REMARKS

Marked-Up Version of Amended Paragraphs and Claims (37 C.F.R. § 1.121)

Fig. 3

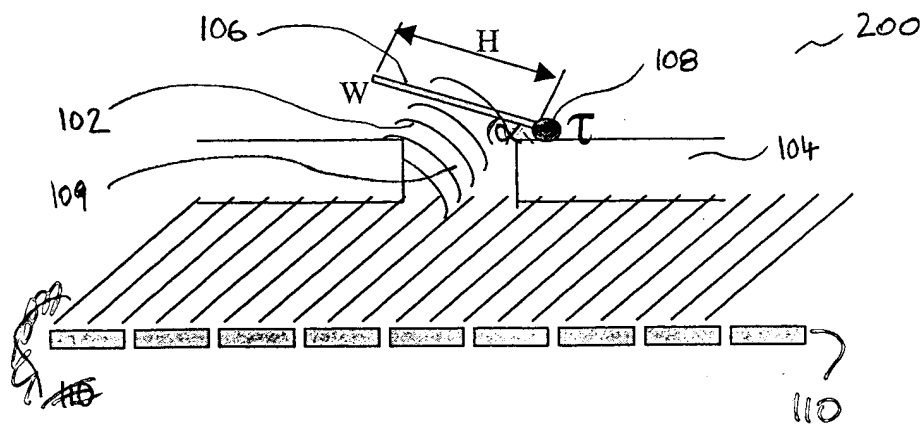
Fig. 3 is voluntarily amended to correct a clerical error. The line pointing to element 110 (an array of MEMS acoustic transducers) erroneously points to an angled launched acoustic wave rather than to the array of MEMS acoustic transducers. An appropriate correction of Fig. 3 is carried out and a copy of the Fig. 3 showing the change in red is submitted with this response for review by the Examiner. No new matter is introduced into the figures by way of this amendment.
